Docket Item # 1 & 2  
BAR CASE # 2013-0042/0043

BAR Meeting  
March 20, 2013

**ISSUE:** Permit to Demolish/Encapsulate and Addition/Alterations

**LOCATION:** 317 South Union Street

FIRST FLOOR PLAN  
3/16" = 1'-0"

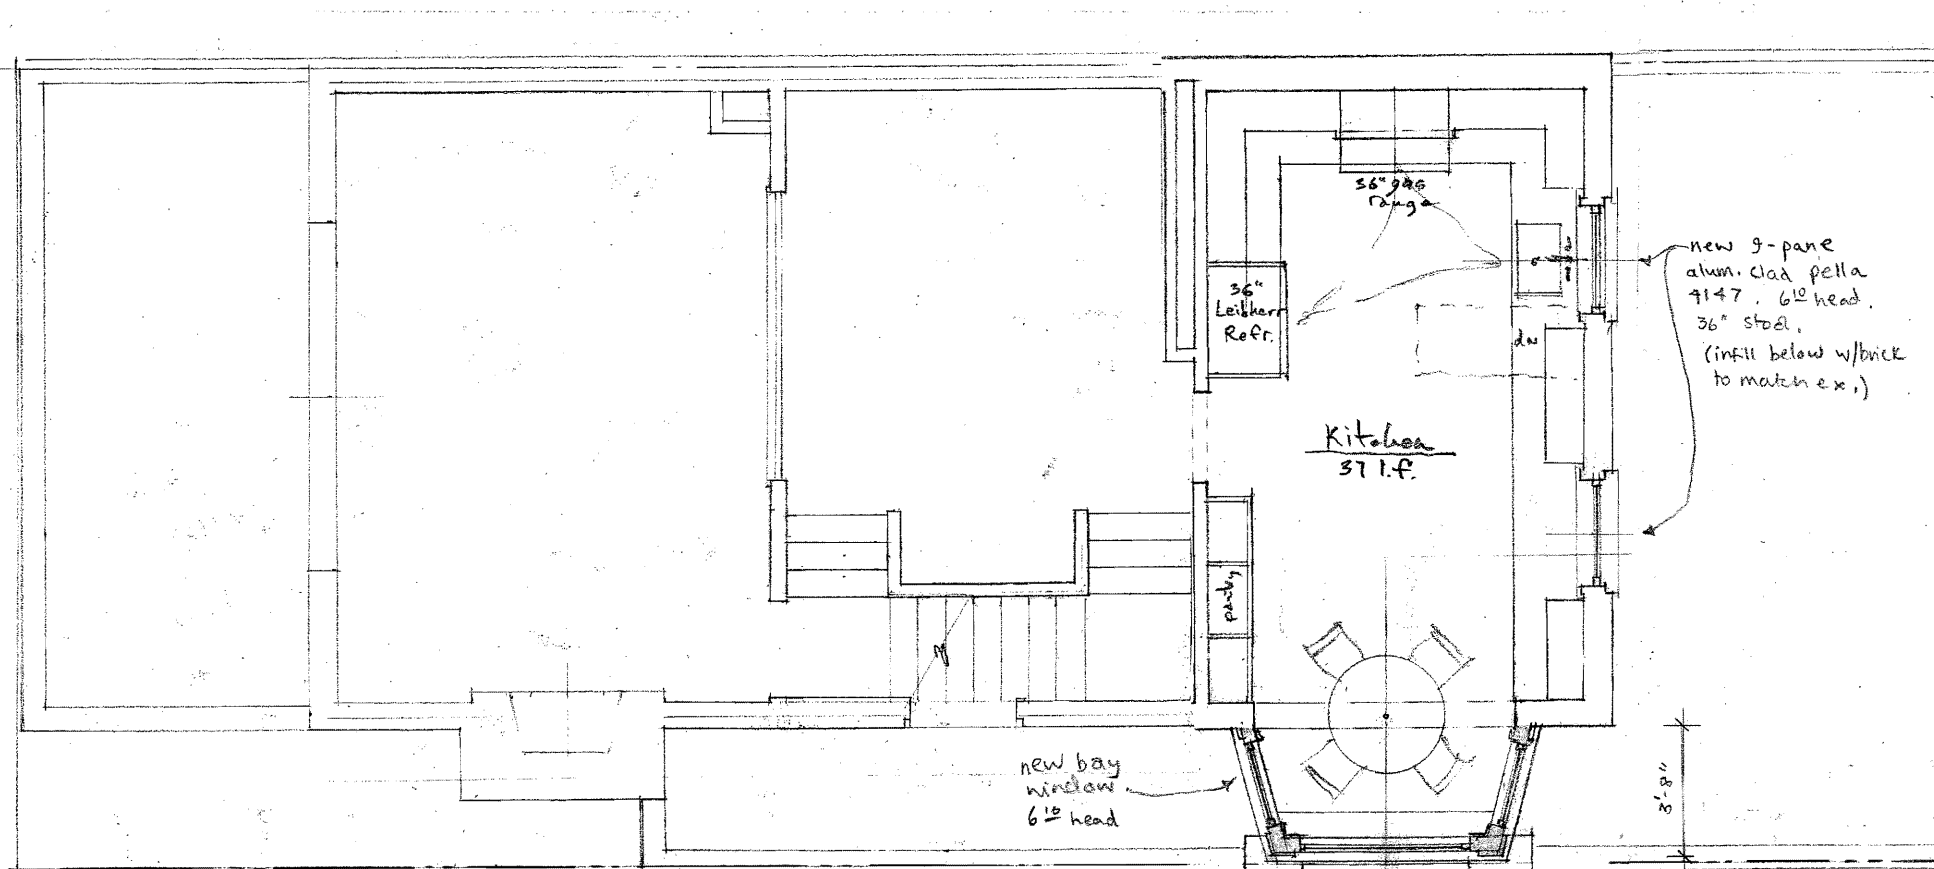
Regarding the new bay window addition, Staff has no objection to the proposed second story bay window as it is not on the street-facing elevation and is well detailed. Although it is unusual to anchor a bay window on the brick piers of a brick wall and the result will somewhat obscure the front entrance, staff finds that it is a successful design, noting that the front entrance of this townhouse is not particularly prominent in its current form.

SOUTH ELEVATION

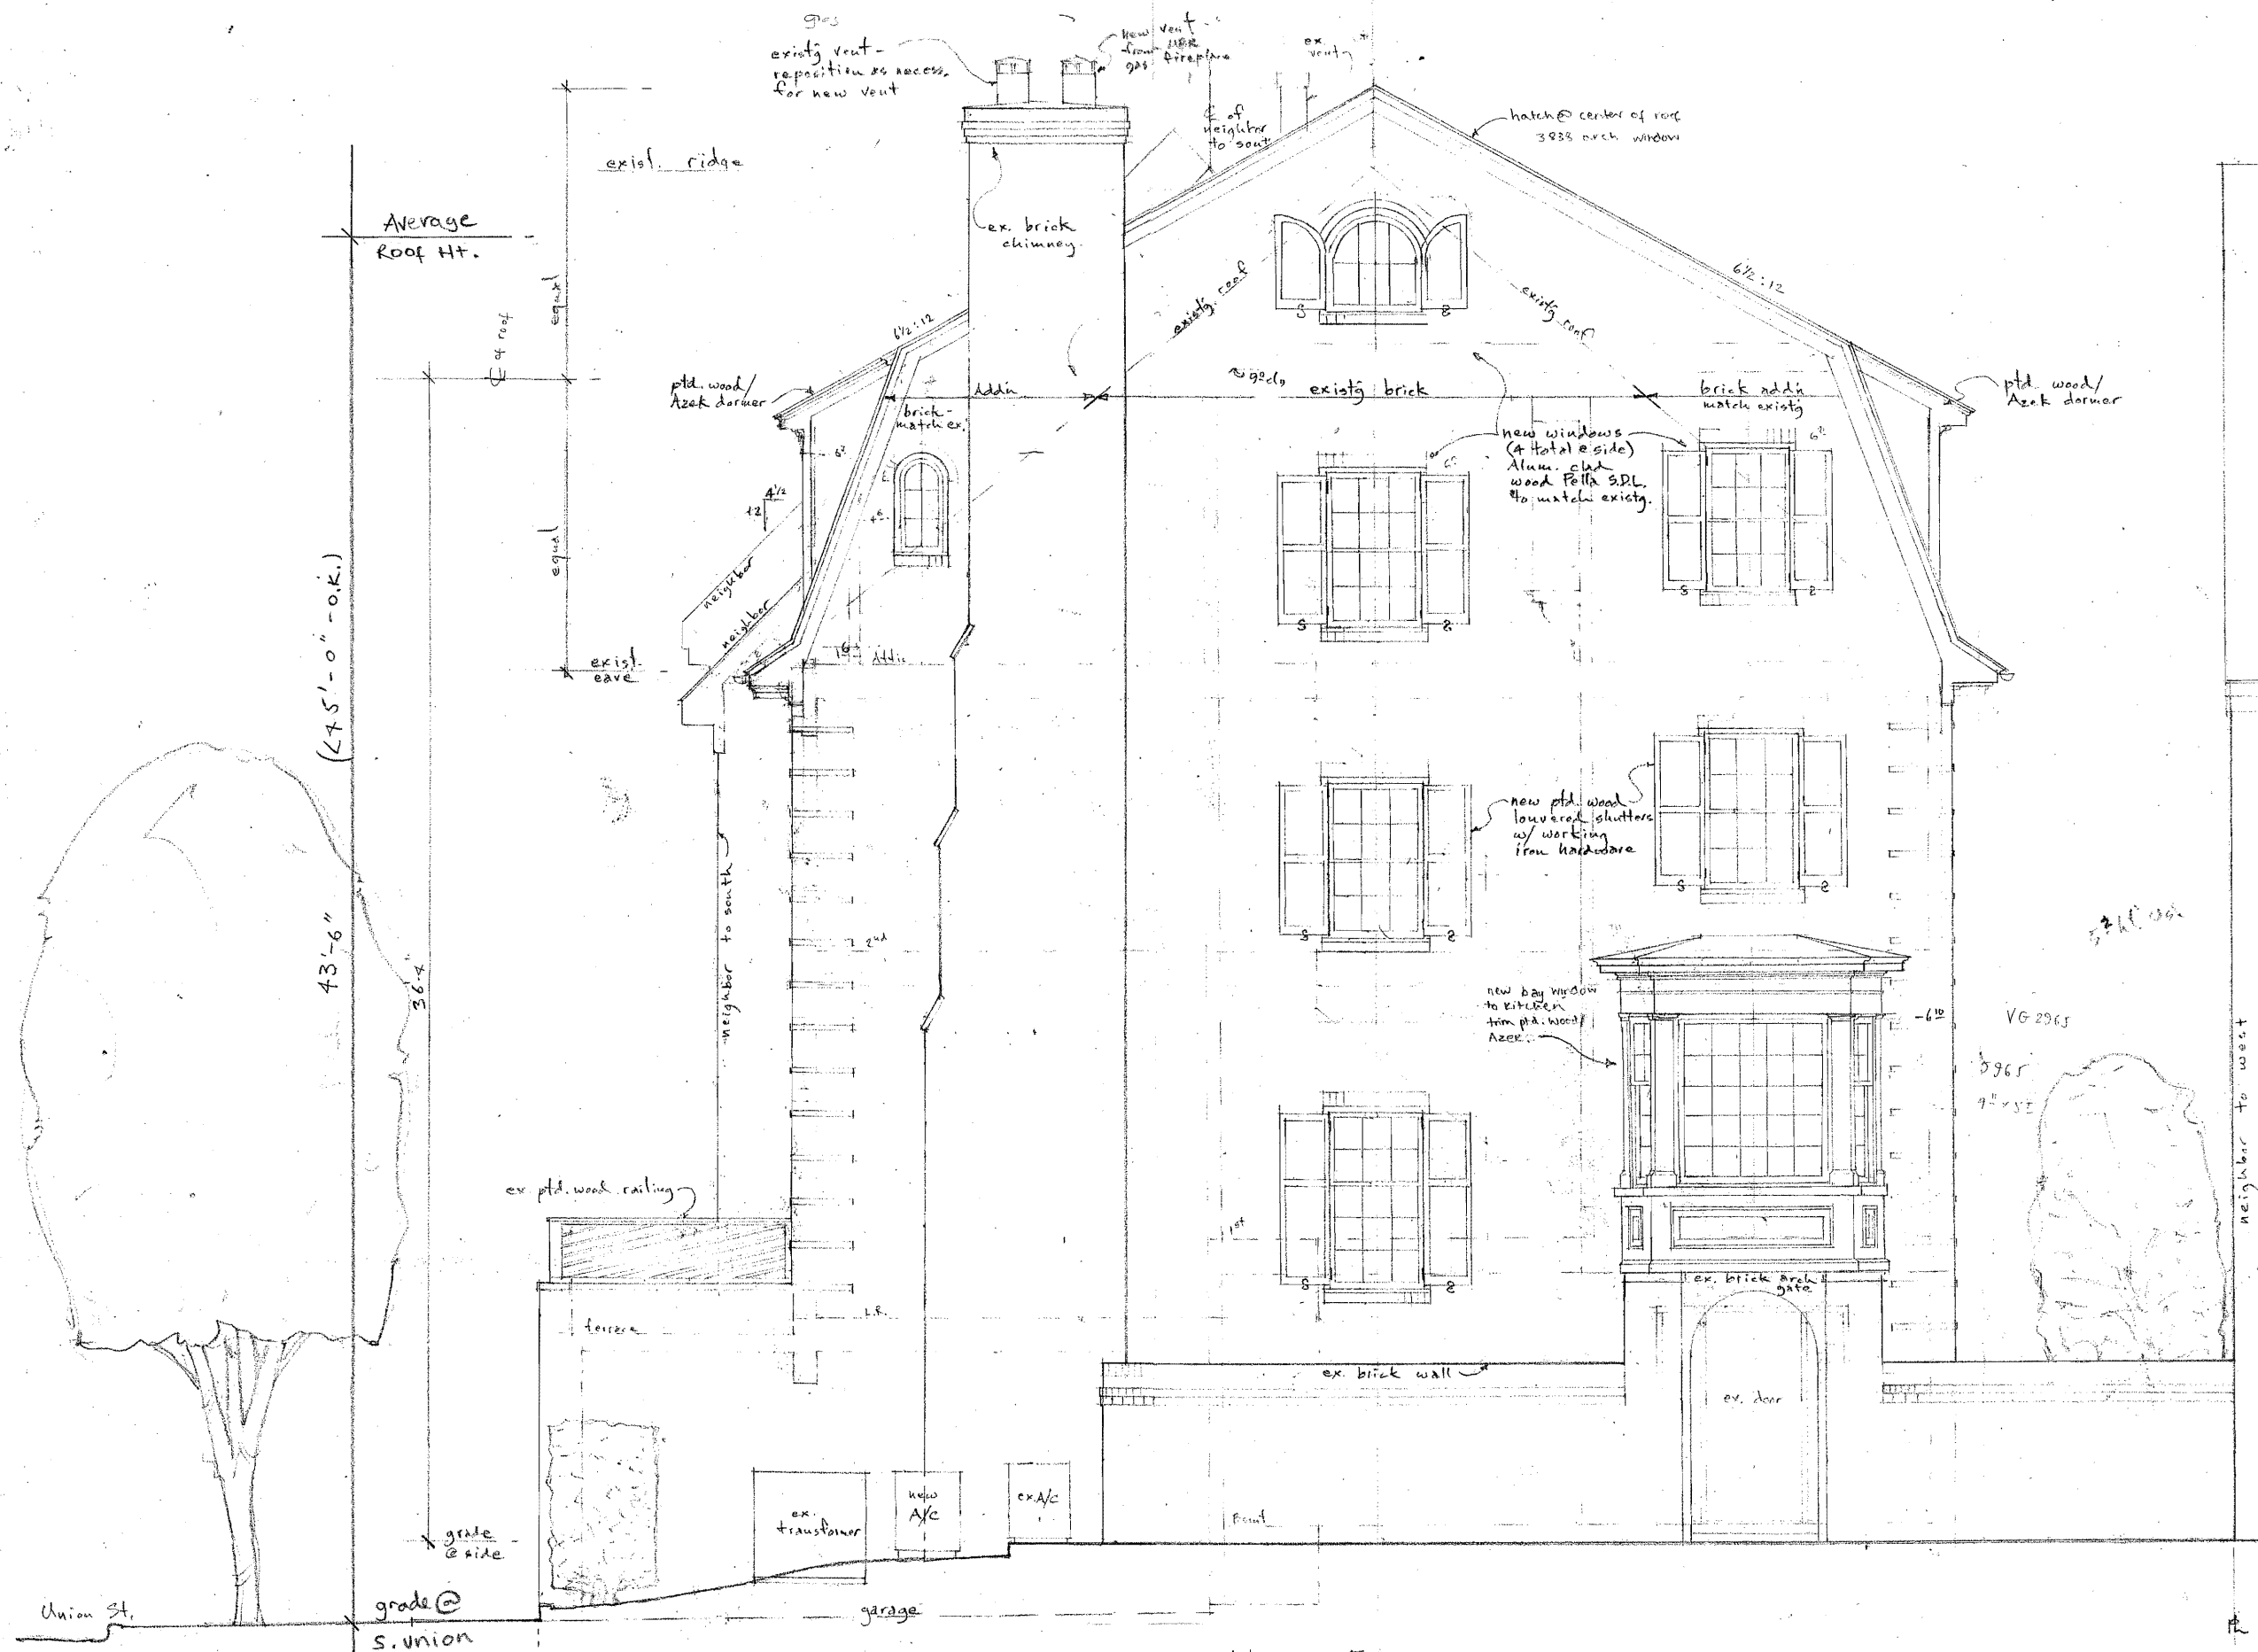
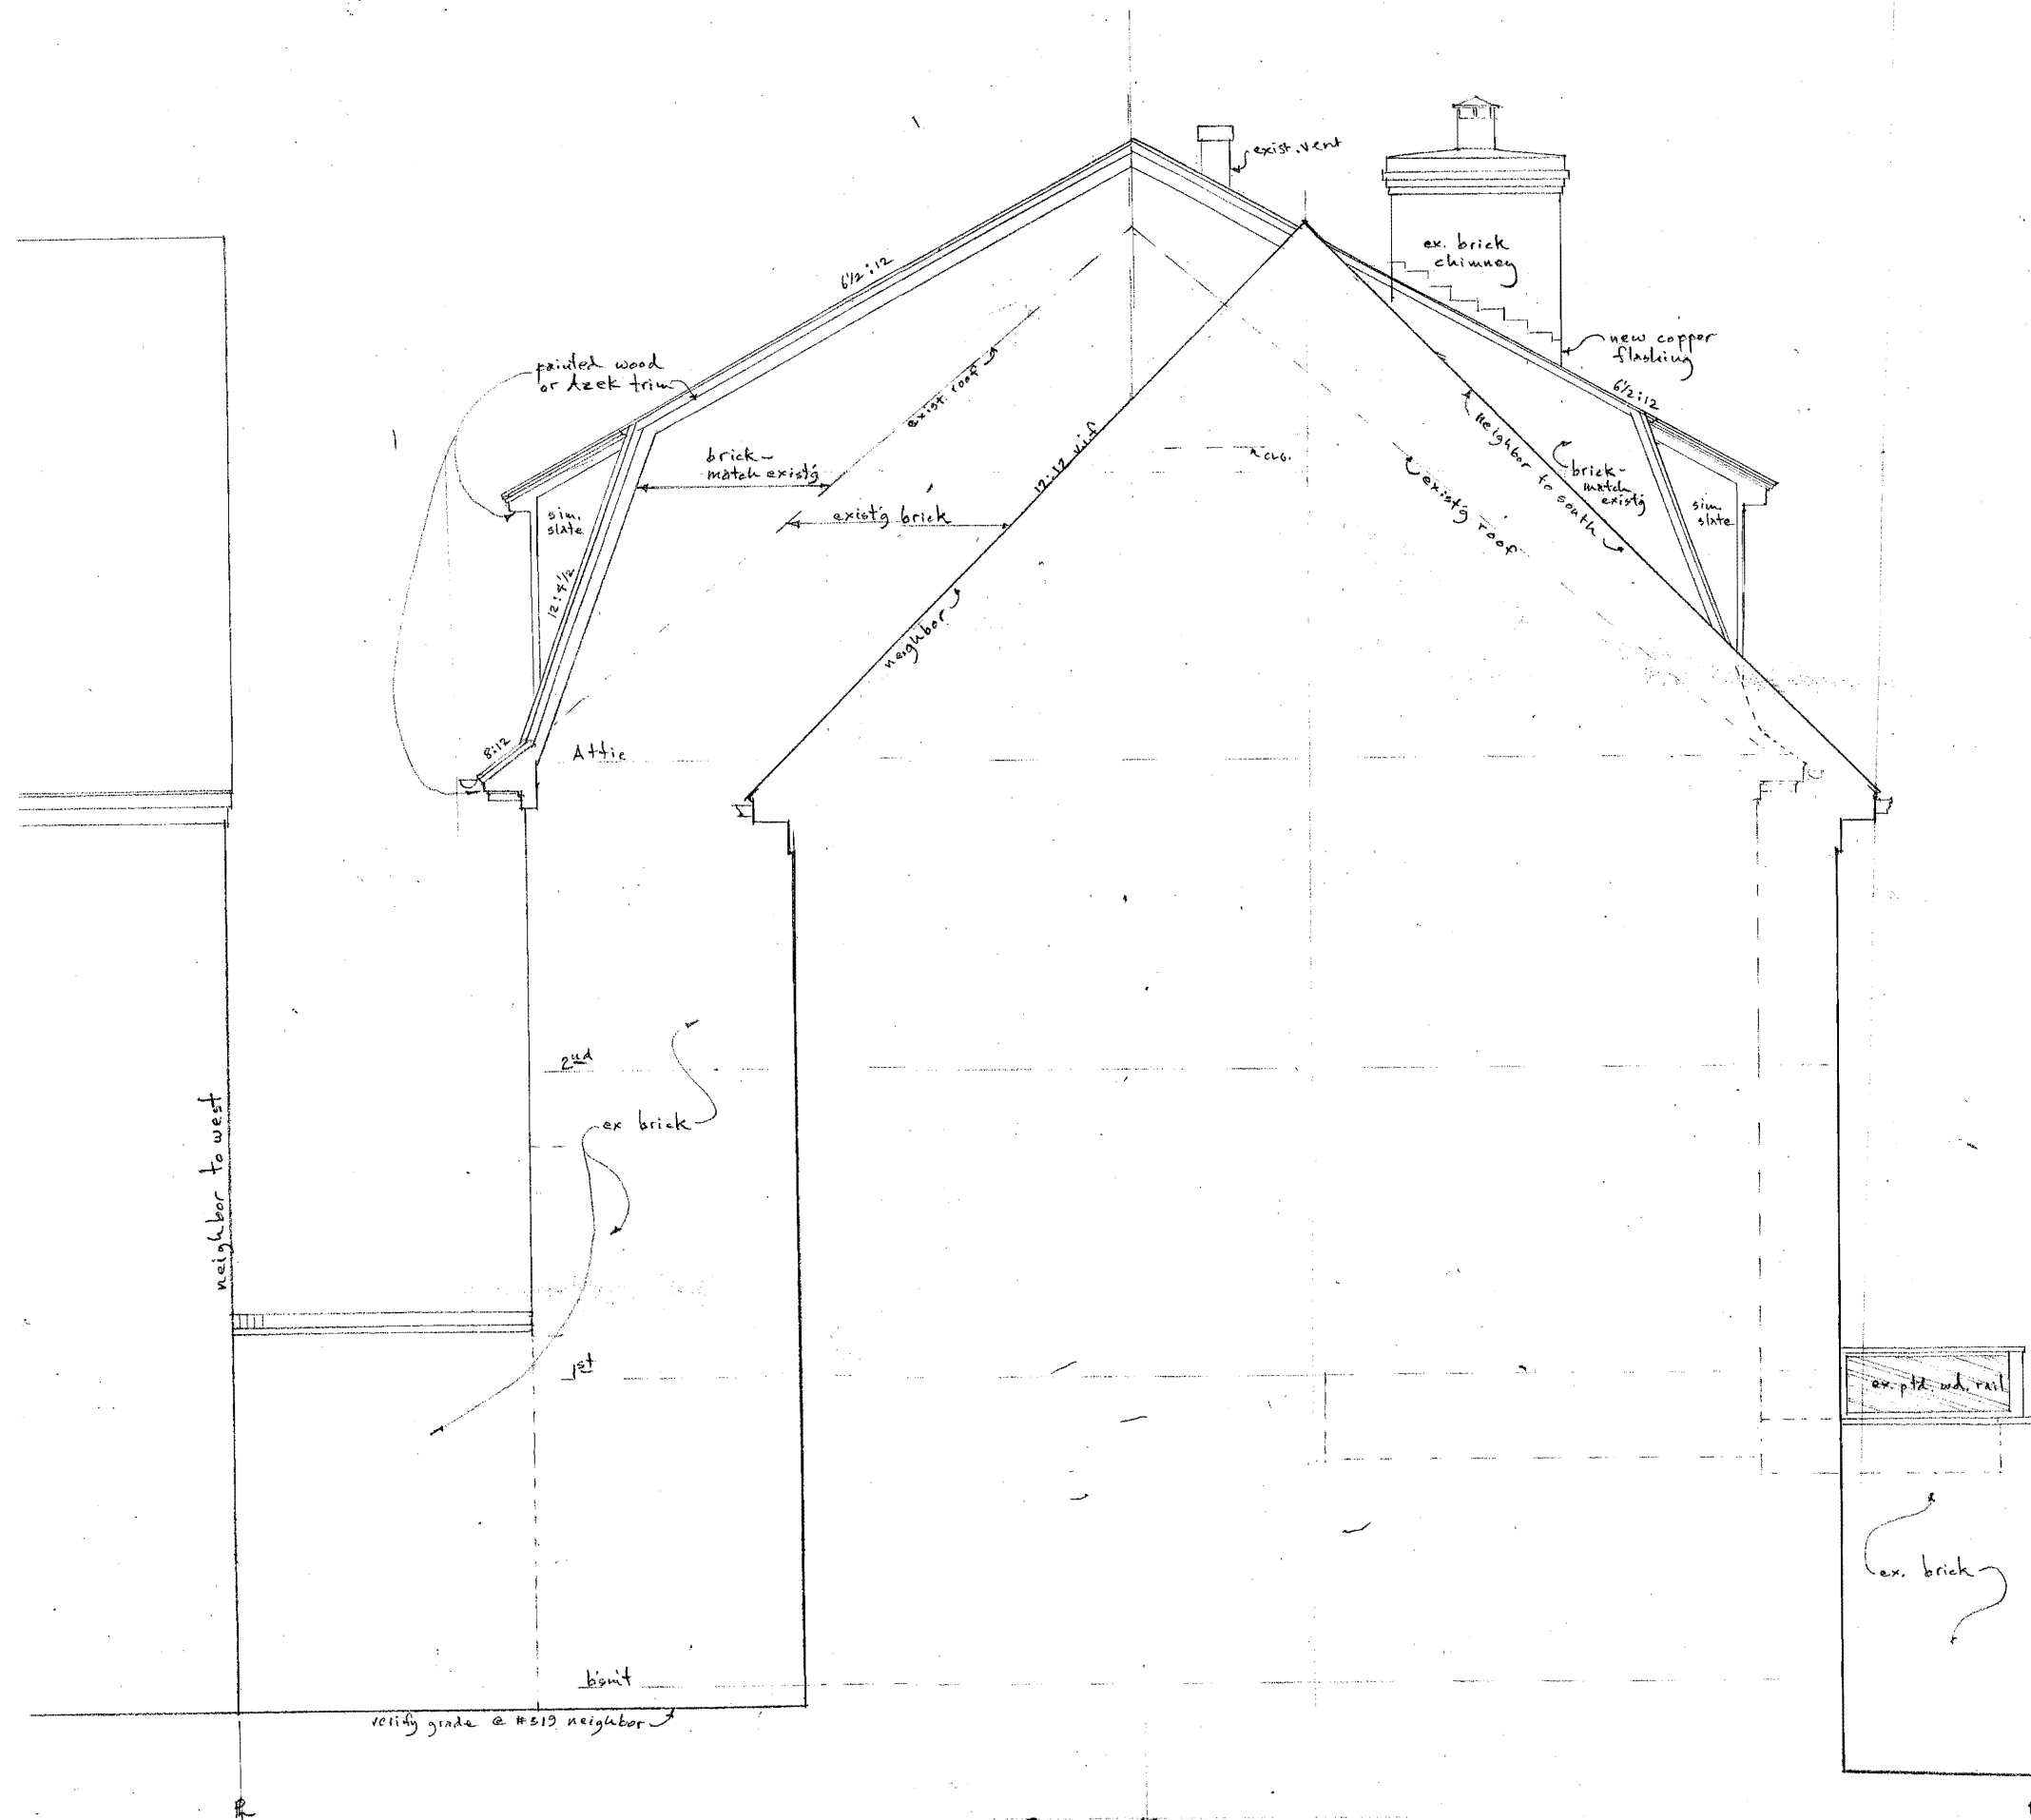
respectful of the existing structure and which seek to be background statements or which echo the design elements of the existing structure.” While the Ramsay house and the Mayor Hooe house are the most prominent examples, there are several historic gambrel roofs found nearby in the district. There are a variety of different roof forms, roof slopes and architectural detailing throughout the Waterford development, so altering this particular townhouse’s roof will not result in an imbalance of scale or design detail with respect to the rest of the development. The use of a gambrel roof form allows for an addition with a modest expansion of the existing building envelope. While it could potentially be overwhelming with respect to scale and massing to build out every upper half story in the district, Staff finds that it is an appropriate design solution in this particular circumstance and does not believe that it will not overwhelm the existing townhouse nor the surrounding buildings. Many of the buildings in the historic district have evolved and grown over time and the changes proposed to this building are not unlike historic changes found throughout the district, such as the Second Empire-ization of the Delaney Realty building at 131 North Washington Street, complete with the addition of a mansard roof and a pronounced bracketed cornice. The gambrel roof form (the English term for the French Second Empire style Mansard roof) substantially improves the architectural interest of this simple, highly visible north elevation and is a better termination for this string of late 20<sup>th</sup> century townhouses on South Union Street. The current submission includes a slightly steeper slope for the gambrel roof and Staff supports this change.

- C-3 Proposed height will be greater than 35.00 feet. The RM zone (3-1106(D)) allows a height increase if the ridge is parallel to the street and the slope of the roof is compatible with the neighboring buildings. The BAR must determine the roof slope compatibility to grant the height increase to 45 feet.
